ECU00002175: Proposed Corriegarth 2 Wind Farm Supplementary Environmental Information (SEI): Response to Ironside Farrar Stage 1 Checking Report – Review of Peat Slide Risk Assessment

In reference to the above project, Arcus Consultancy Services Ltd (Arcus) has prepared this clarification letter in response to the Ironside Farrar Ltd Stage 1 Checking Report (the Checking Report) dated August 2022. This response supersedes the previous 'draft' version circulated on 28th September, and has been informed by discussion with Ironside Farrar and the Energy Consents Unit (ECU) on 30th September 2022.

Outline Mitigation Within Medium Risk Zones
Clarification Figure 3a

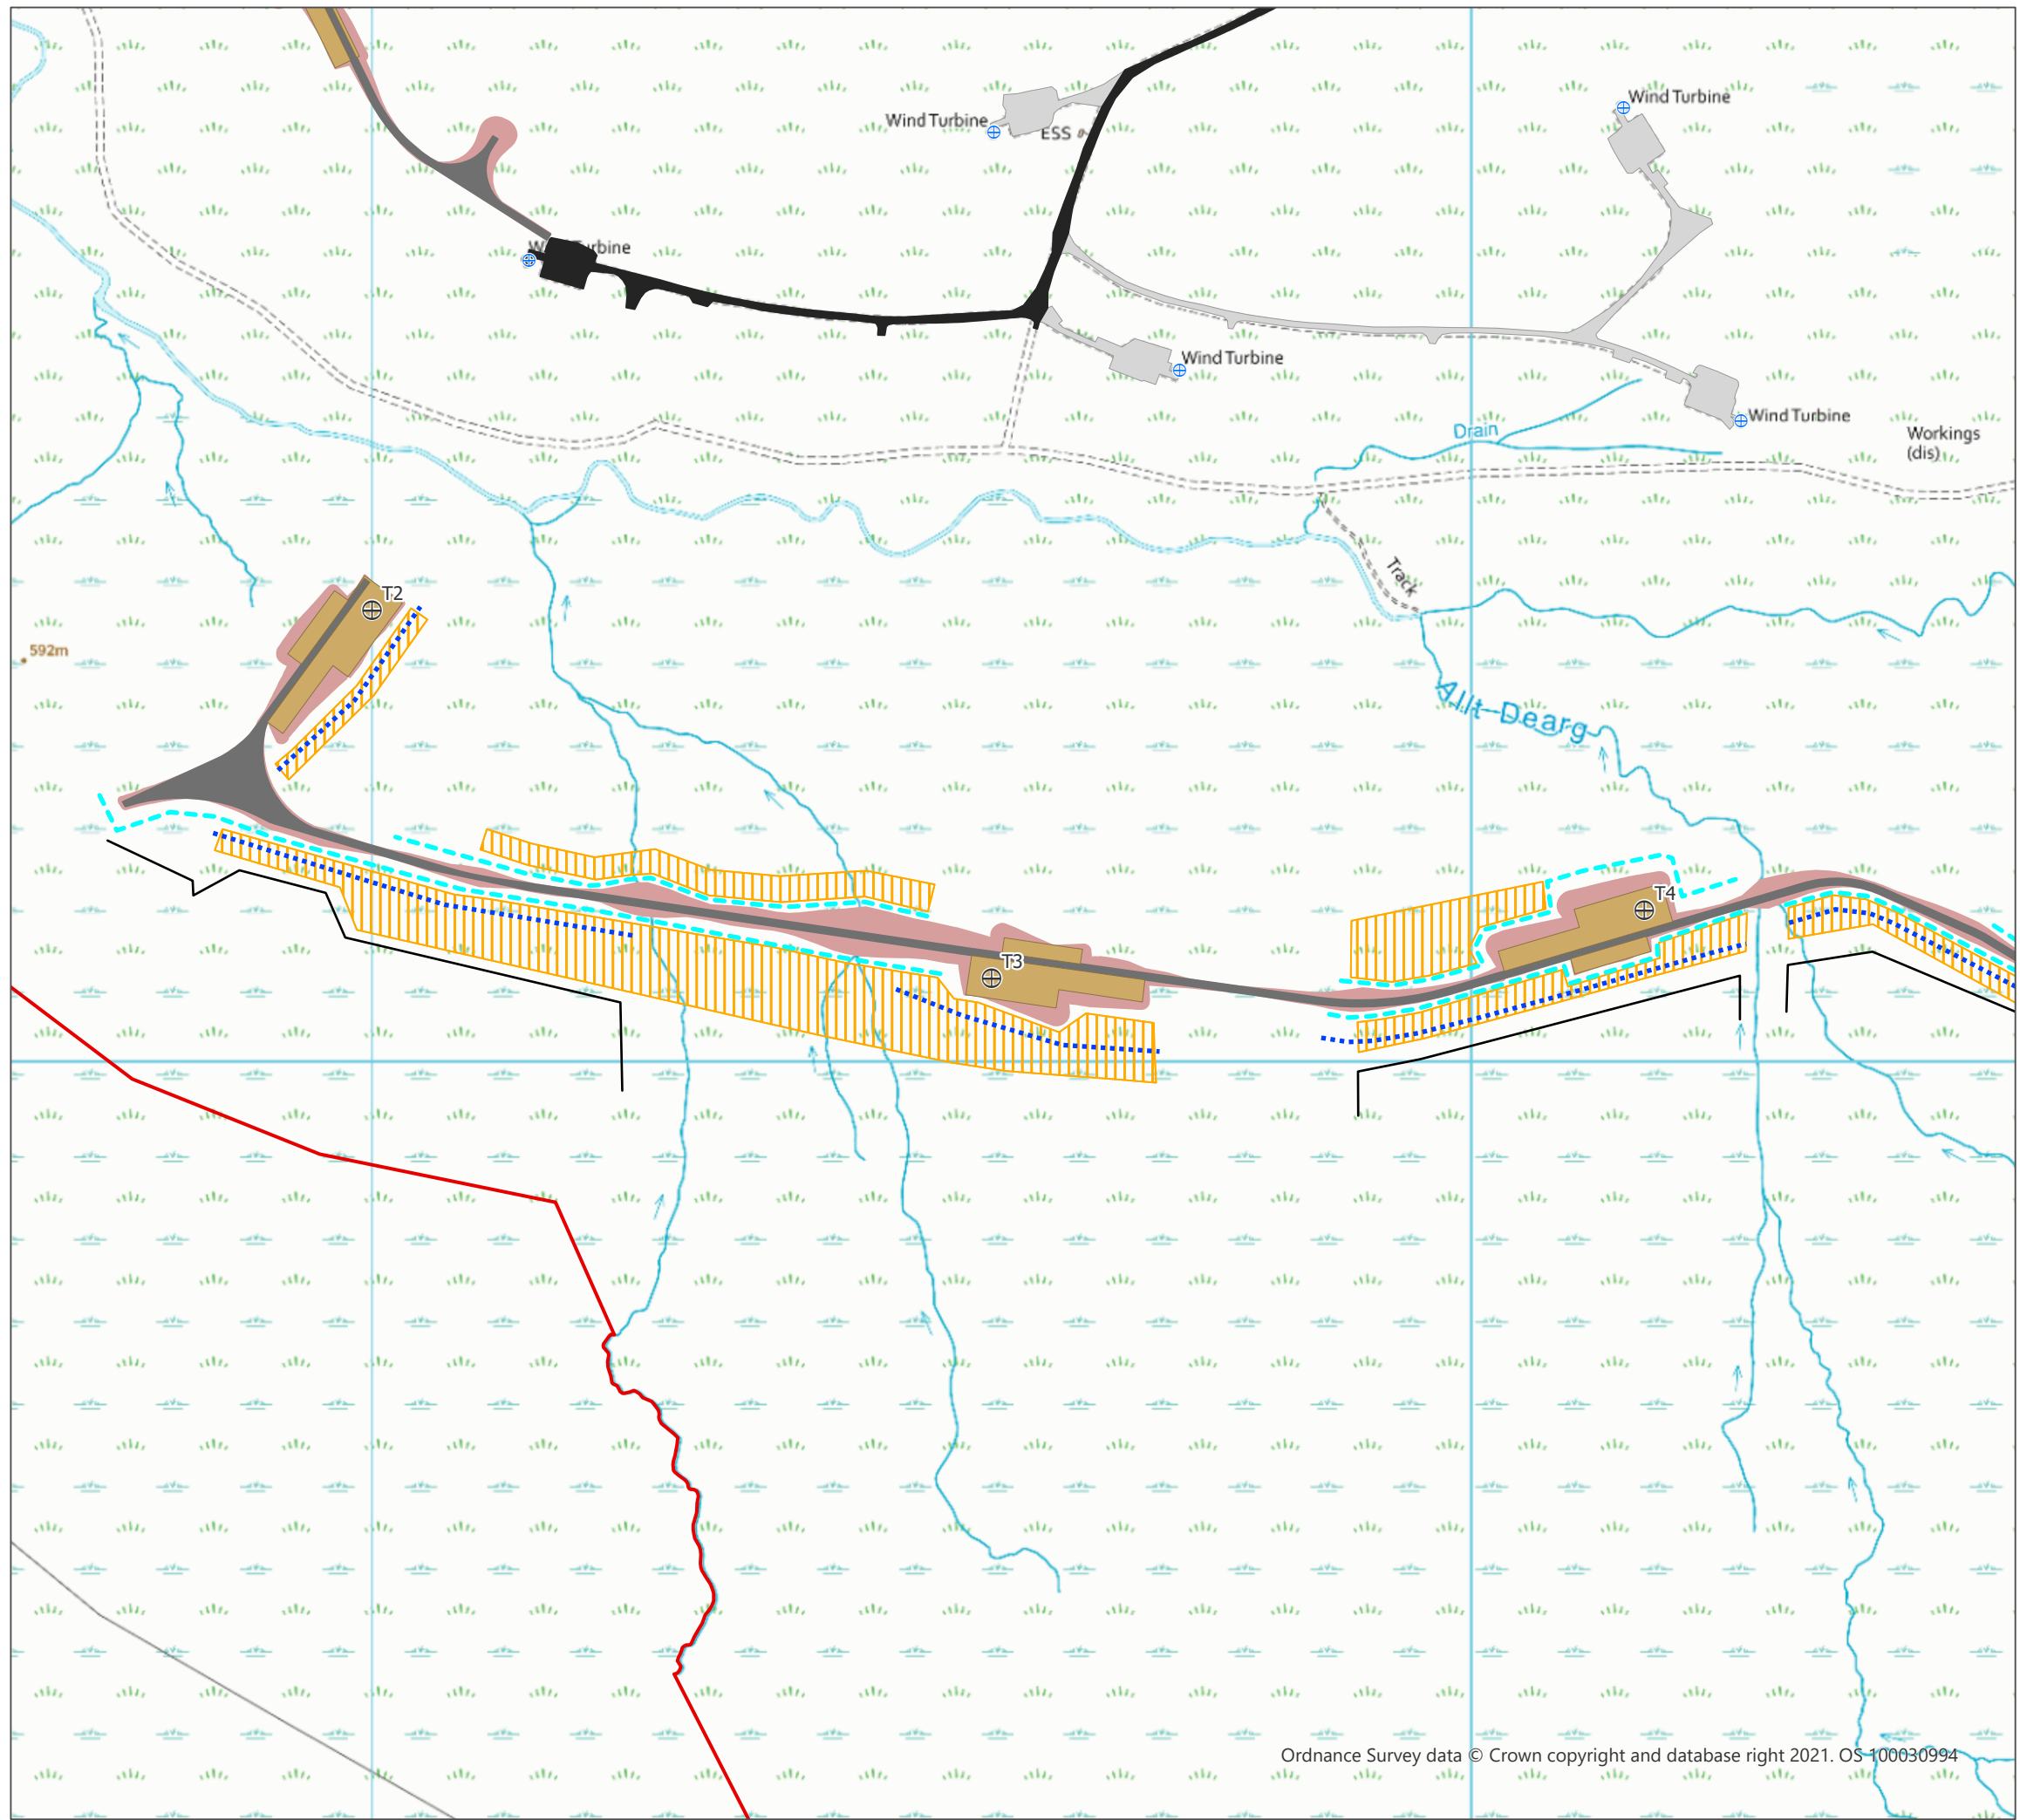
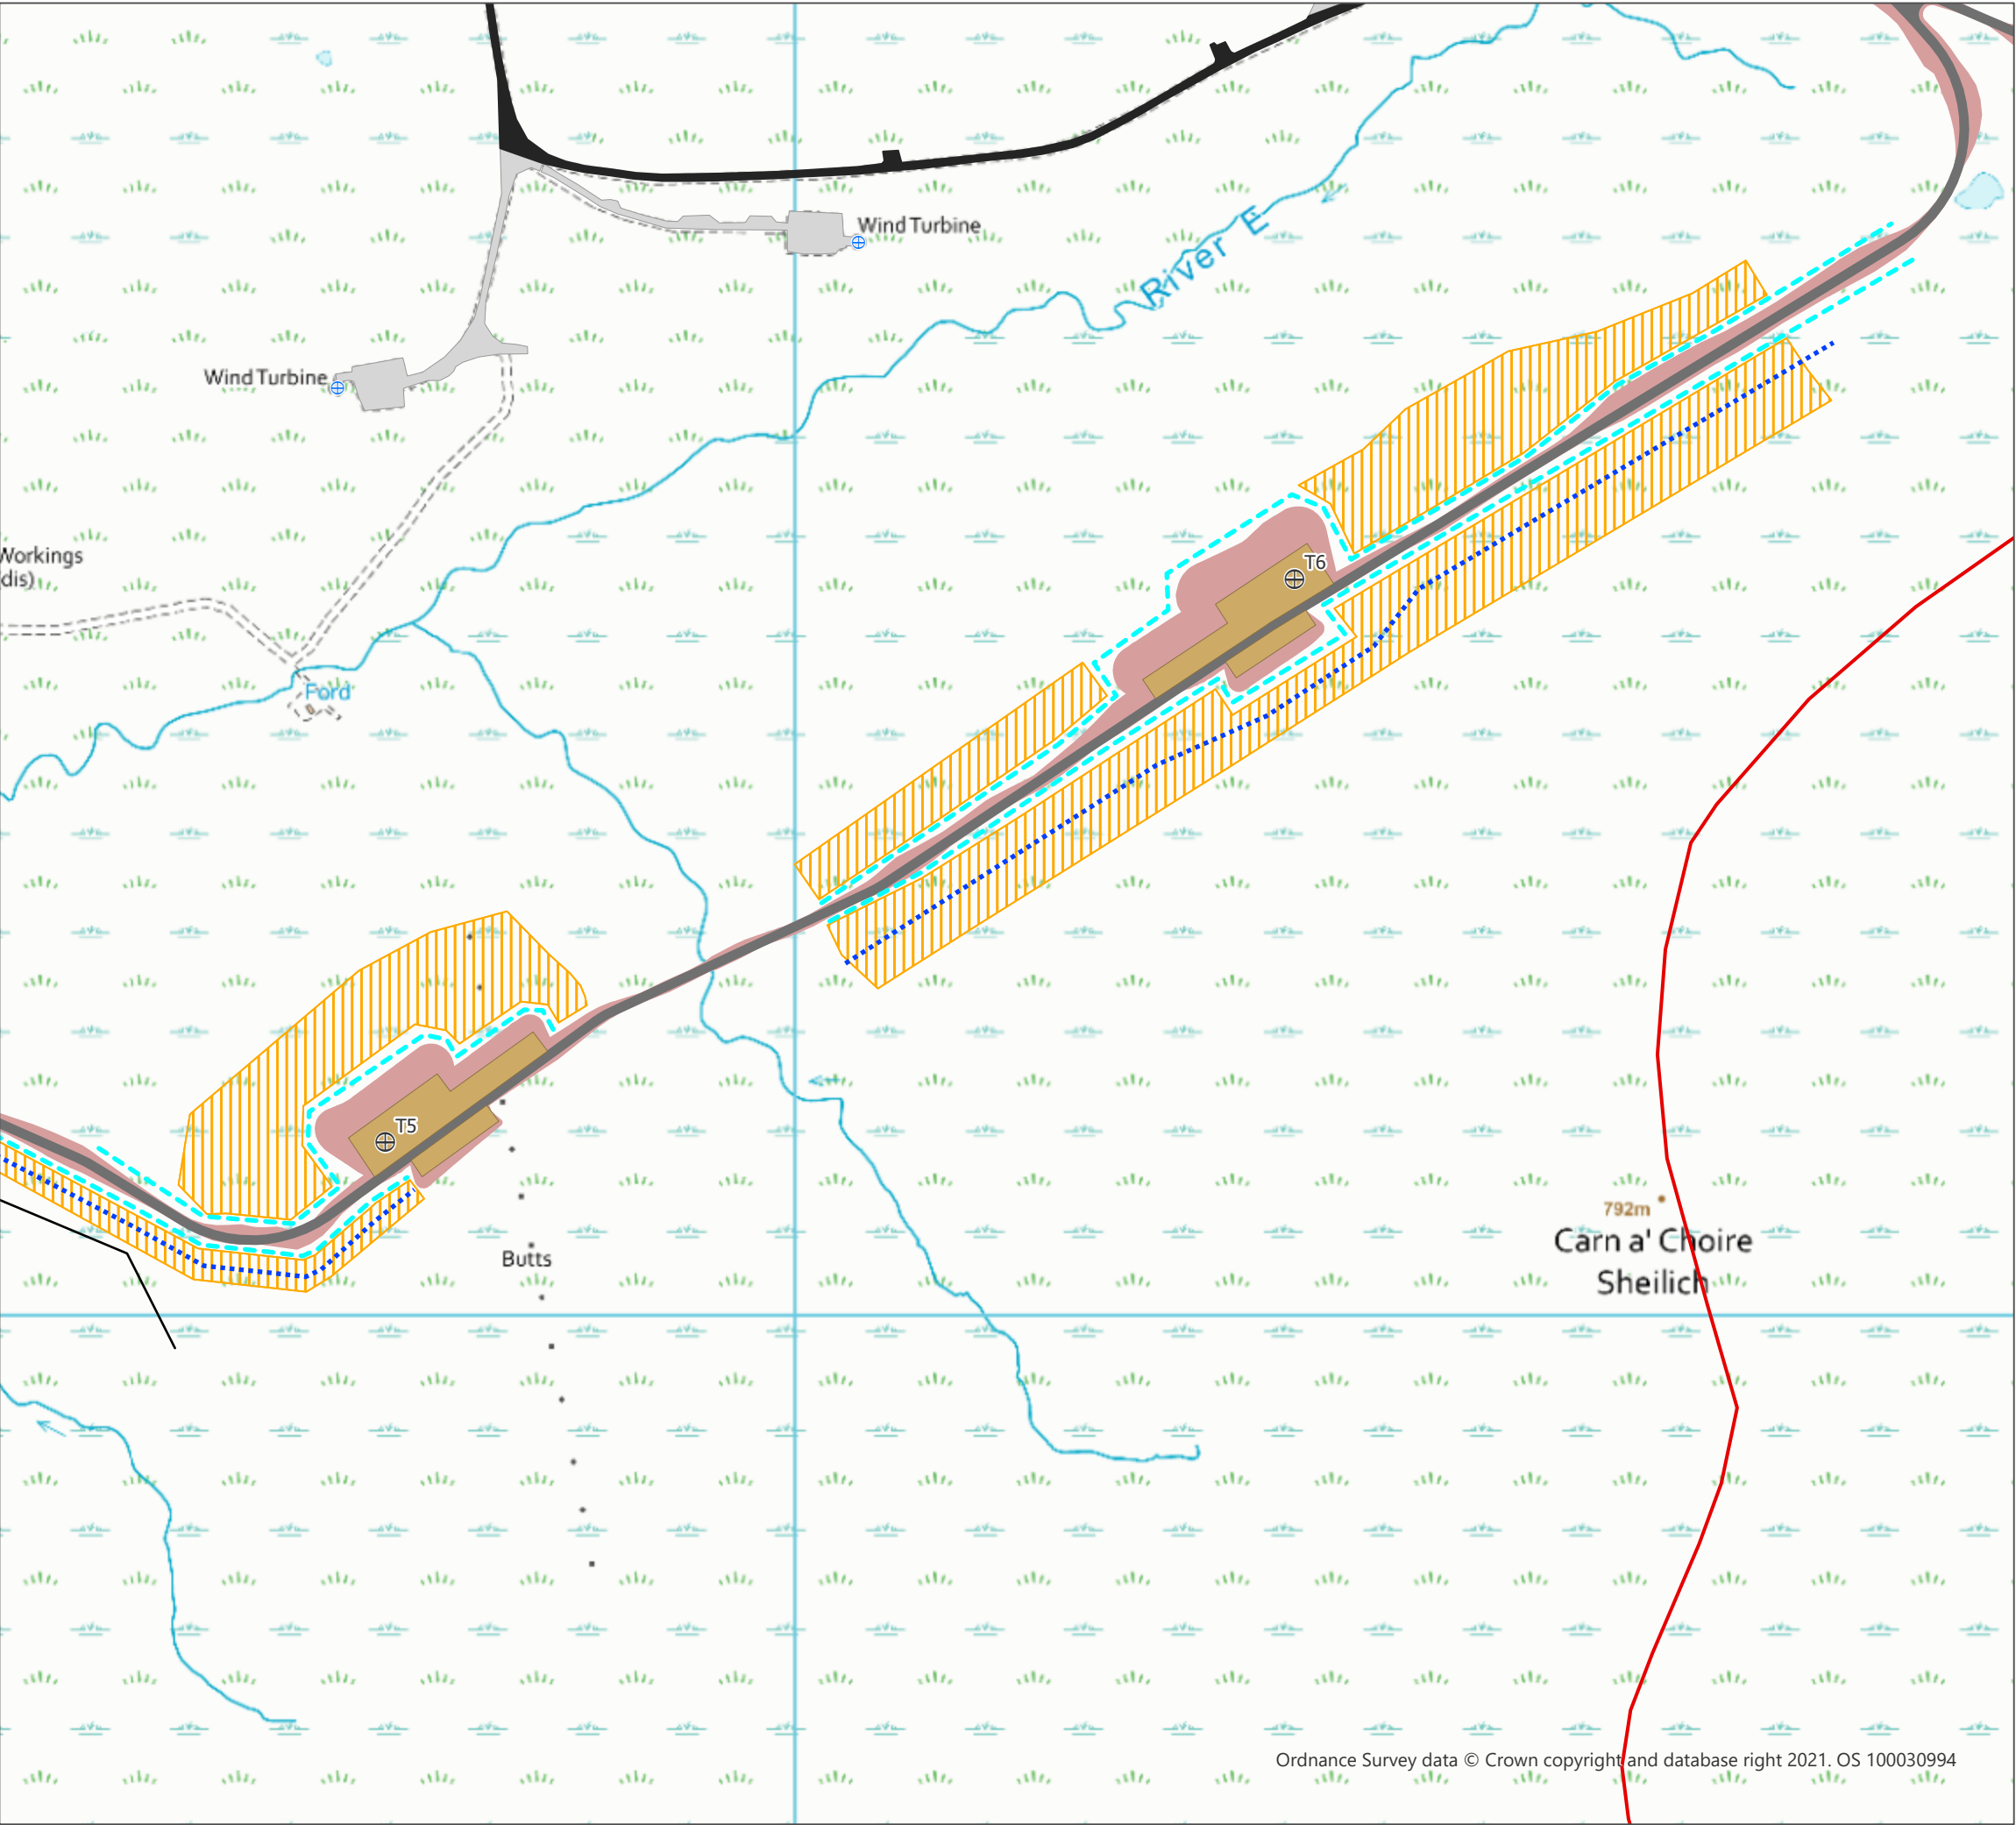
The mitigation provided in Table 15 is considered generic and not specifically targeted to the risks identified in the risk assessment. Further detail / clarification of practices is required particularly in the case of medium risk zones in order to satisfy the ECUBPG.

Proposed mitigation is illustrated on Clarification Figure 3 (and Figure 3a to 3d) included in Appendix A of this letter. These measures presented on Clarification Figure 3 are the minimum proposals that will be in place during construction, however intrusive geotechnical investigation and detailed design will inform the

Specific mitigation in the areas of medium risk hazard as identified on Clarification Figure 3 (and Figure 3a to 3d) includes the following:
